UNITED STATES PATENT AND TRADEMARK OFFICE

APPLICATION NO.	FILING DATE	FIRST NAMED INVENTOR	ATTORNEY DOCKET NO.	CONFIRMATION NO.
09/847,901	05/02/2001	Masajiro Inoue	SIW-008	7510

Office Action Summary

The instant application is directed to a fuel cell wherein the disclosed inventive concept comprises the specific seal feature.

FIG. 3

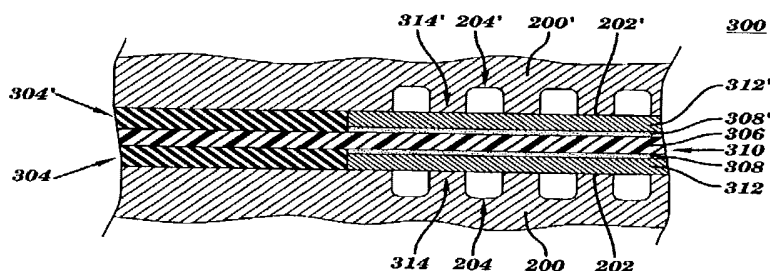
Figure 3 shows fluid flow plates serving as flow field plates in a fuel cell.

As seen in Figure 3, fuel cell 300 includes the membrane electrode assembly (MEA) 310 comprising a solid polymer electrolyte 306, catalyst 308 and 308' which facilitate chemical reaction are applied to the anode and cathode sides, respectively of the solid polymer electrolyte.

For purposes of illustration, Figure 3 also depicts the fuel cell with fluid flow plates 200 and 200' serving as flow field plates (it is noted that separator plates are sometimes referred to as flow field plates, that is, separator plates are also conventionally known in the art as flow field plate), in particular, flow field plate 200 might serve as an anode side of the fuel cell, and flow field plate 200' might serve as a cathode side of the fuel cell. That is, face 202 might comprise an anode face, and face 202' might comprise a cathode face (col 6, lines 44-50).

Jones discloses that gasketing material or gaskets 304, 304' can be employed to seal peripheral holes. A given gasket might take the form of, for instance, a frame gasket made from polytetrafluoroethylene material (col 6, lines 34-42). As depicted in Figure 3, the gasketing material 304, 304' contacts the end faces of both gas diffusion layers 312 and 312'.

As illustrated in Figure 3, the edge of solid polymer membrane 306 extends beyond (extended/projecting portion) the end faces of the anode and cathode side; and the gasketing material 304, 304' contacts the extended portion of the solid polymer electrolyte.

As shown in Figure 3, the gasketing material 304, 304' contacts the end faces of both gas diffusion layers 312-catalyst 308 and gas diffusion layers 312'-catalyst 308' which are considered to be the anode and cathode electrode sides, respectively.

【 2 】

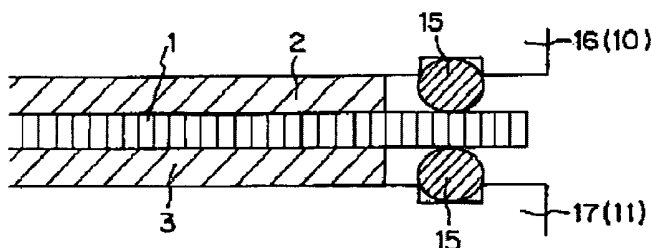
The JP'169 publication illustrates in Figure 2 a fuel cell structure including gas diffusion electrode wherein the separators 16, 17 provide grooves which are contacted and sealed by O-ring seals 15 (Figure 2 and section 0008).

In view of the above, it would have been obvious to one skilled in the art at the time the invention was made to seal Jones' separators by providing grooves thereon (*seal provided in grooves in the separator to seal them*) so as to obtain a seal-groove sealing structure as taught by the JP'169 publication as the JP'169 publication teaches that when plates or frames (separators) constitute the main enclosing member of the fuel cell structure, an O-ring seal disposed between grooves formed in the separator enhances and ensures the adhesion of both separators. Further, the O-ring-grooves sealing feature provides a sealing technique having the advantage of employing adhesive forces without damaging fuel cell elements. Thus, this provides a sealing feature that ensures a sufficient sealing effect only through light pressing of the polymeric electrolyte film of fuel cell, and preventing damages to the electrolyte film per se. *The teaching of JP'169 is also consistent with another embodiment of Jones teaching and encompassing the employment of O-ring gaskets.*
